**Integrated Mitigation Project  
Located Southwest of Briggs Road and Golden Jay Lane  
In the french Valley Community  
Project No. C7-0032**

<b>CONTRACTOR QUESTIONS AND RESPONSES</b>		
<b>53</b>	Question	Is there a geotechnical investigation for this project that can be made available to the contractors prior to the bid date?

PP-6

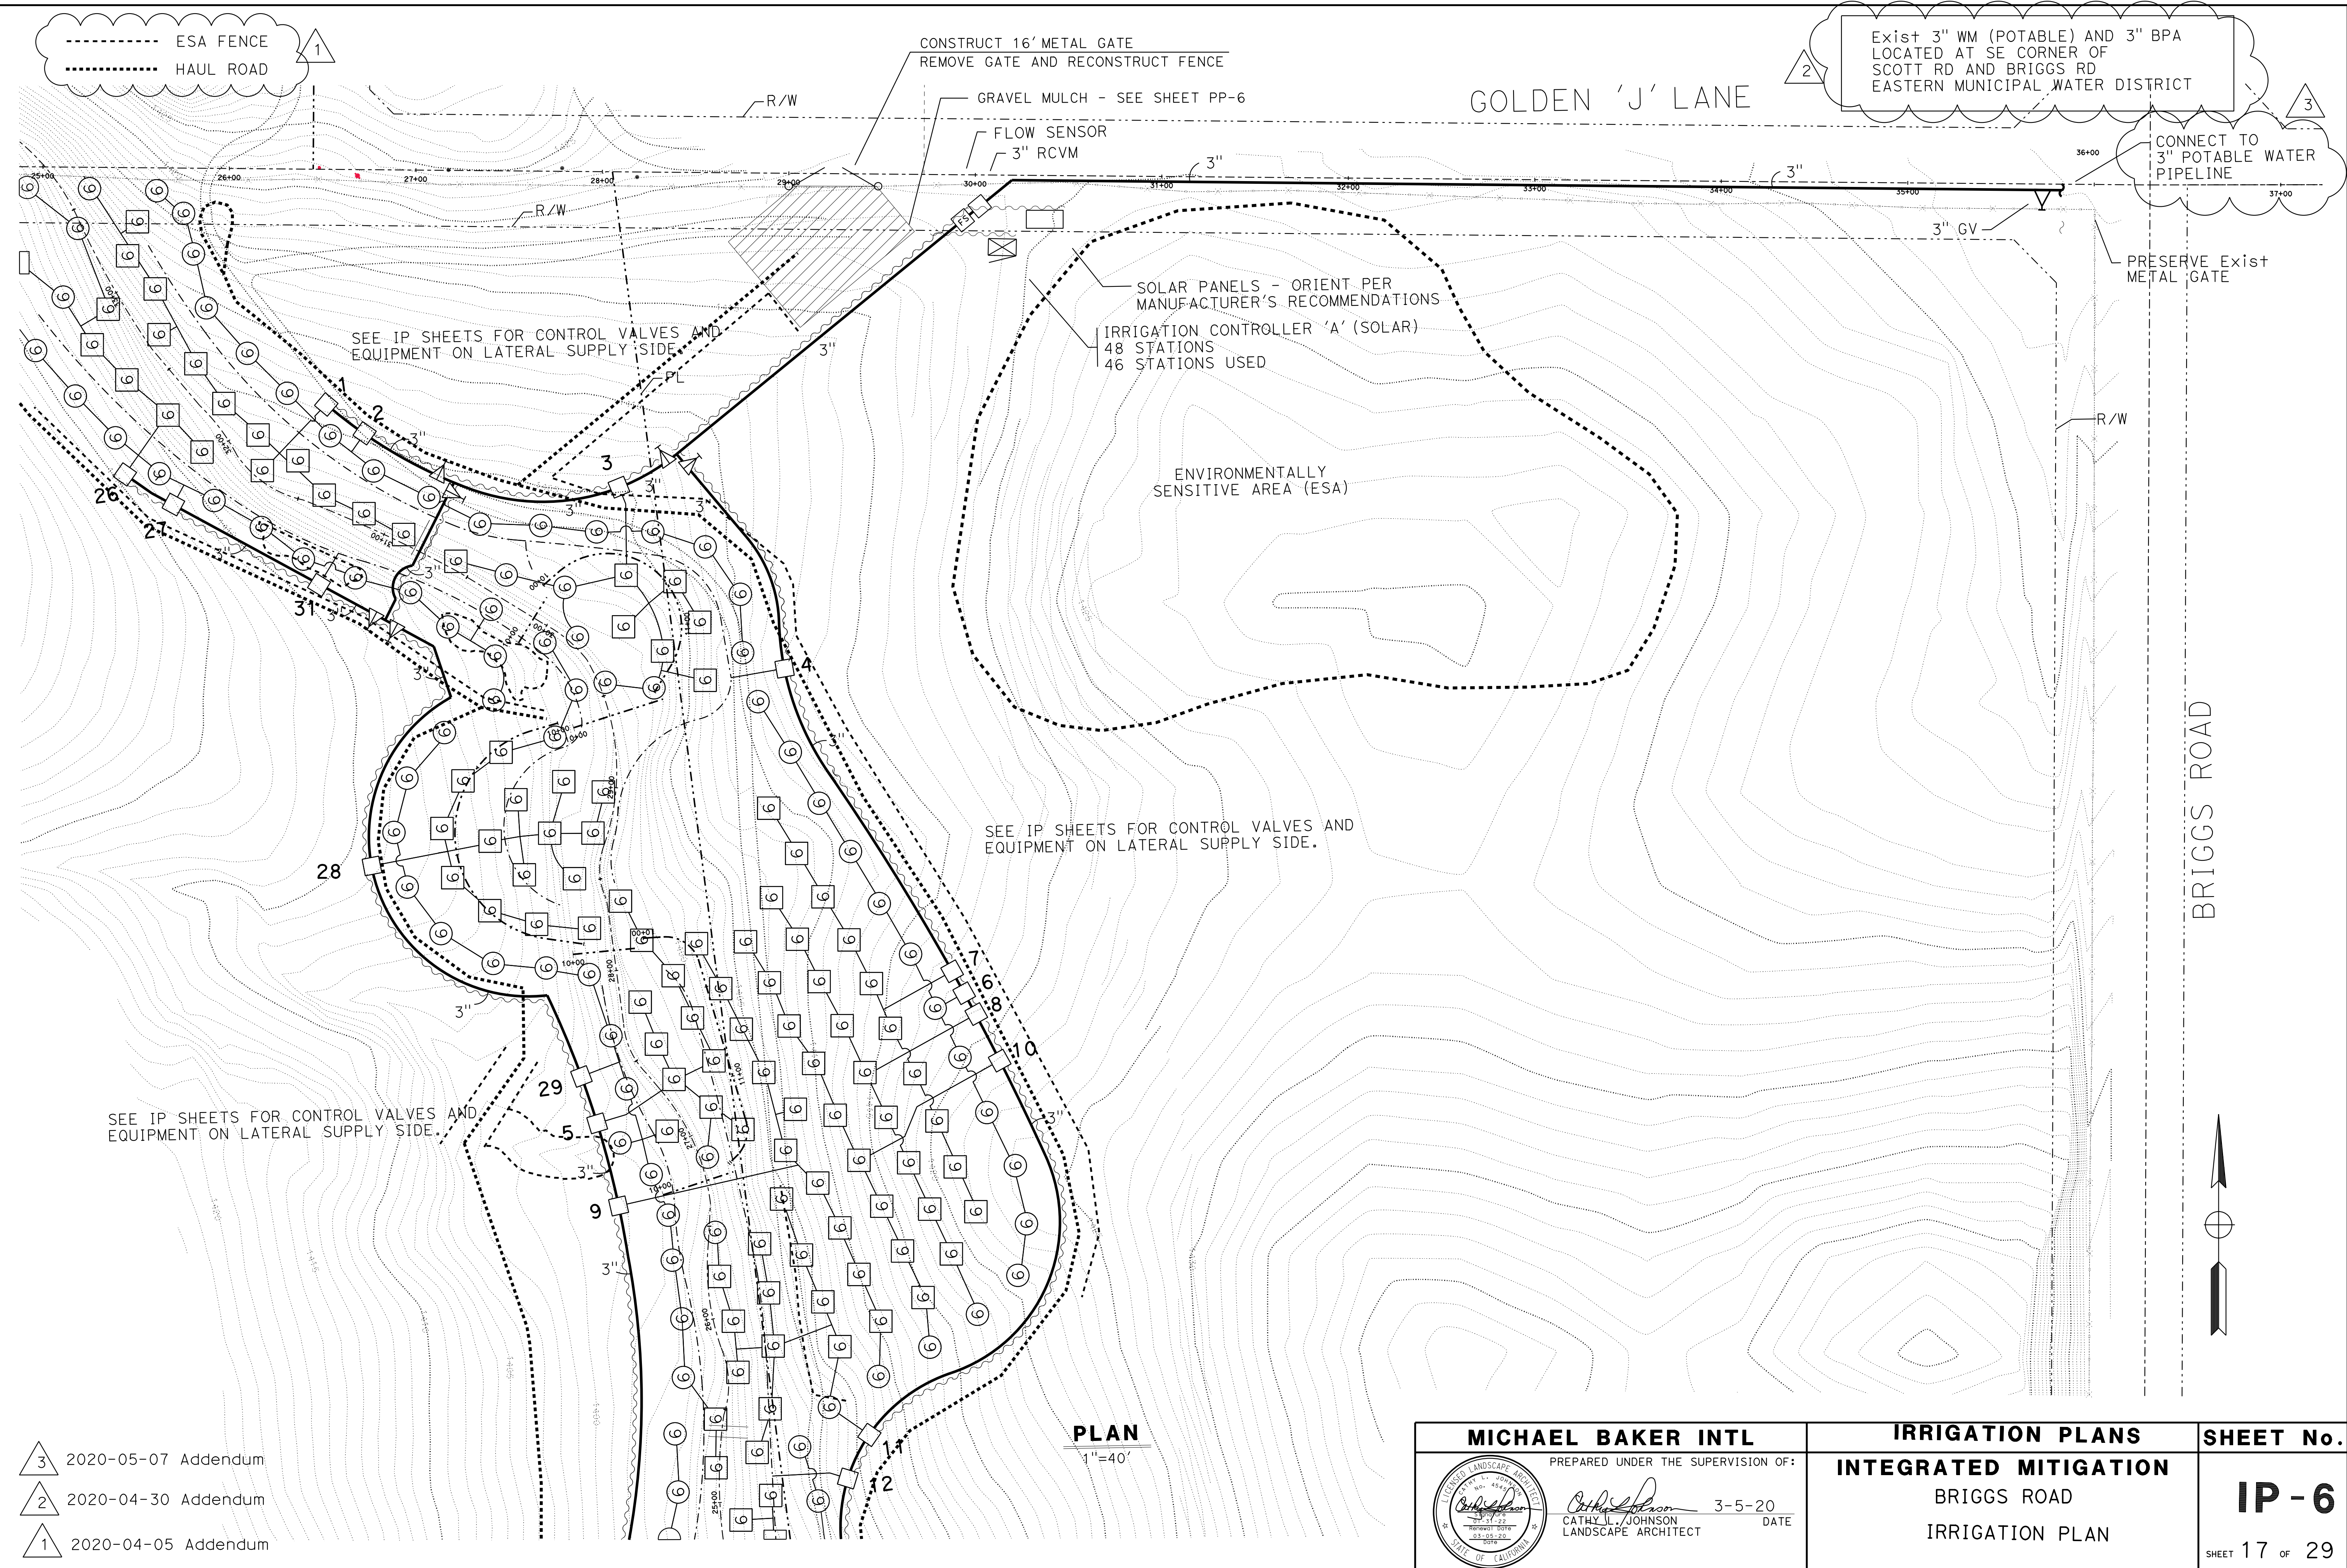
Response	<a href="#">Refer to Revised Proposal item 59.</a>
<b>73</b>	Question	Sheet PP-6 has three notes showing "GATE – SEE SHEET IP-6." One on Golden J Lane and two on Briggs Road. Sheet IP-6 only shows the one location on Golden J Lane. Where is the info for the two on Briggs Road?

<b>CONTRACTOR QUESTIONS AND RESPONSES</b>		
	Response	Please see Sheet IP-1.
74	Question	The Point of Connection note states "CONNECT TO Exist 3" POTABLE WATER PIPELINE." Do we actually connect to an existing 3" water pipeline southwest of the intersection of Briggs and Golden J or do we construct the pipeline shown on sheets 33 through 37 to connect east of the intersection of Briggs and Scott Road?
